# Comment 124: Realigning the Cable Spec

palkert\_3cd\_01a\_0717

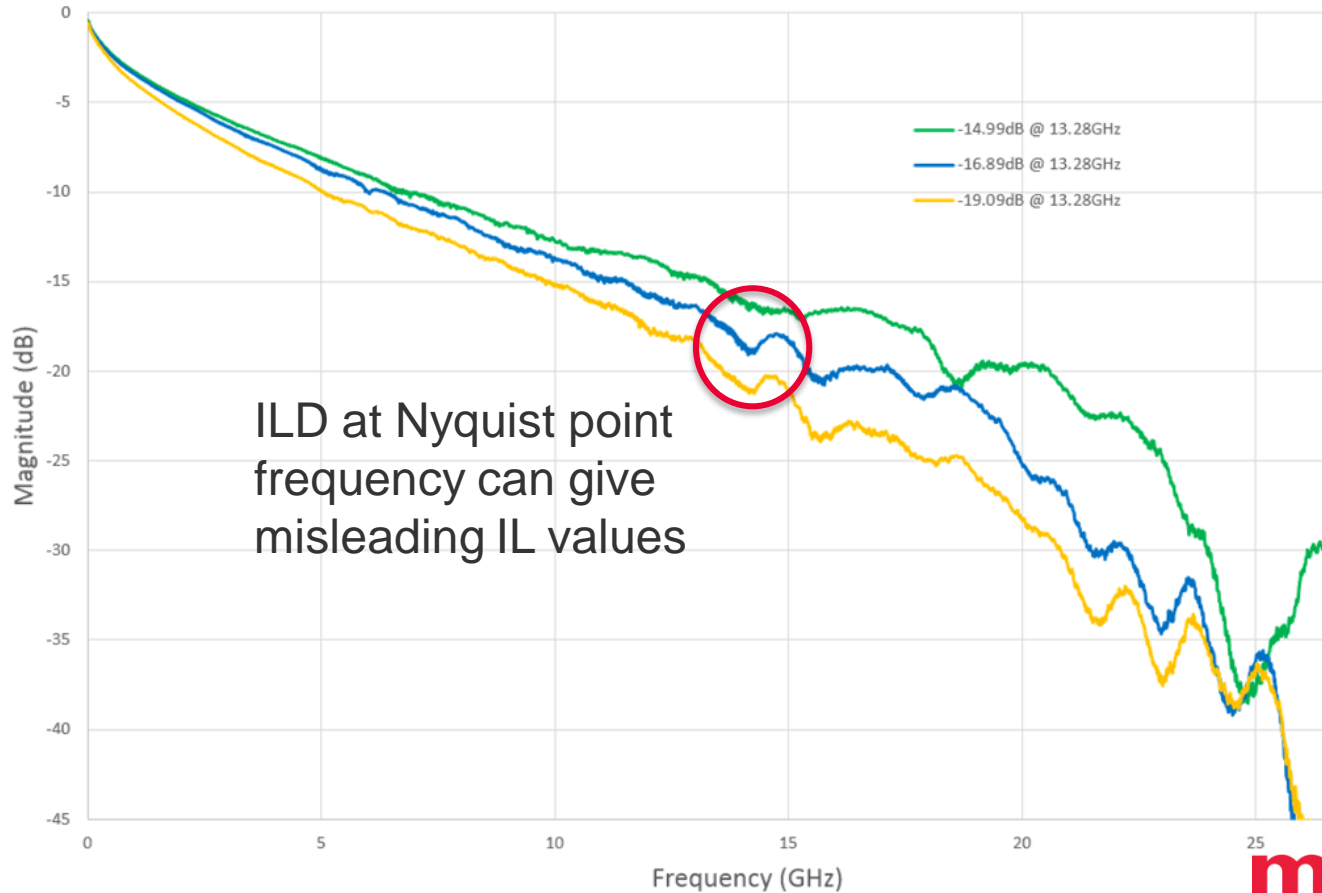
- Insertion loss & COM values are presented for low, mid, and high loss channels
- Data demonstrates the Insertion Loss Limit may be adjusted if other performance parameters (e.g. crosstalk, return loss, etc.) improve proportionally. This allows for new cable types with inherently higher loss to achieve 3m reaches.

# MDNEXT

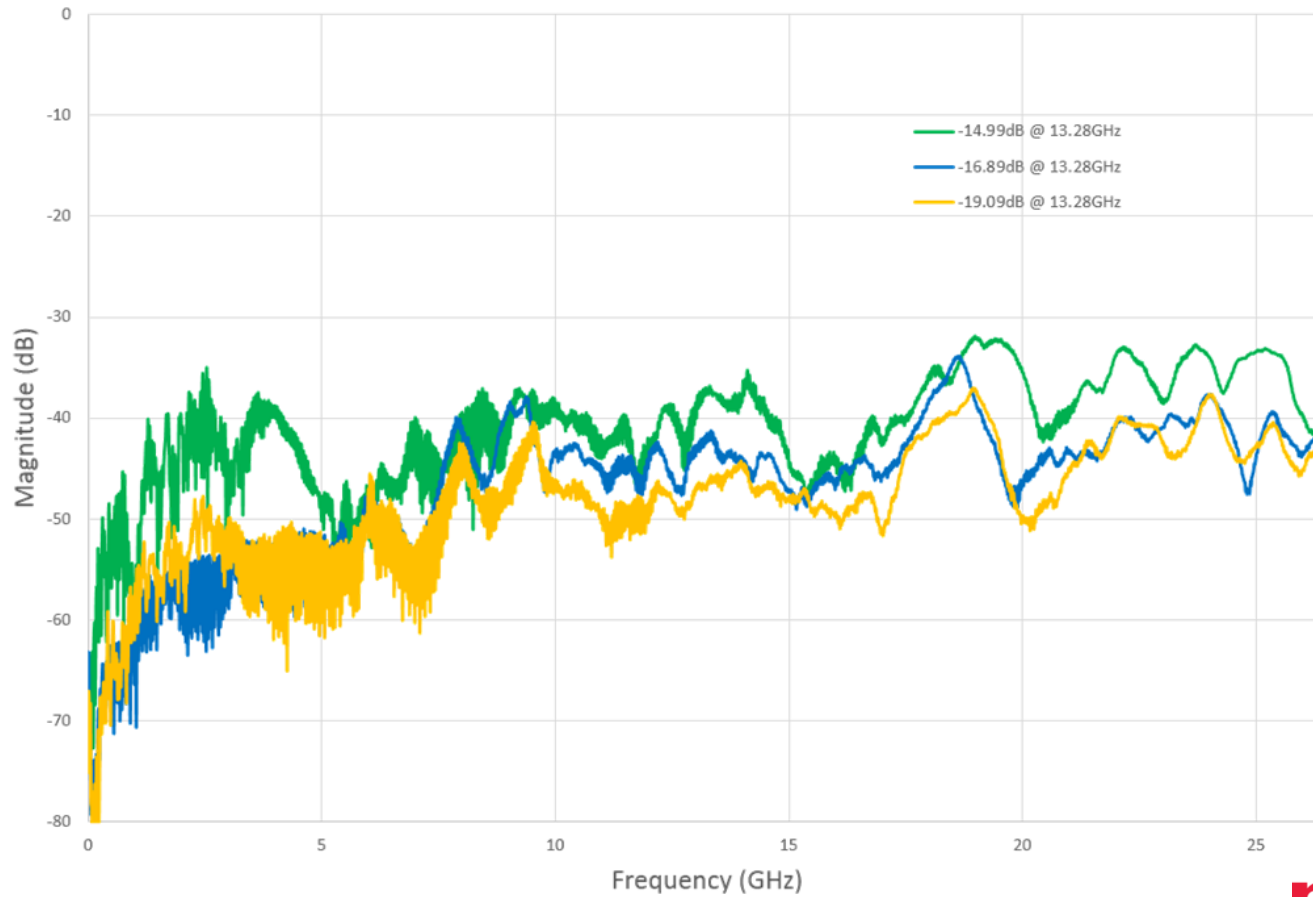
- Enough COM margin exists in high performance channels that the limit on insertion loss can be loosened to 18dB without having a detrimental effect on channel performance
- The current insertion loss limits are unnecessarily restrictive on channels that have wide margin on COM requirements
- Channel insertion loss deviations around the Nyquist point frequency can give misleading IL measurements
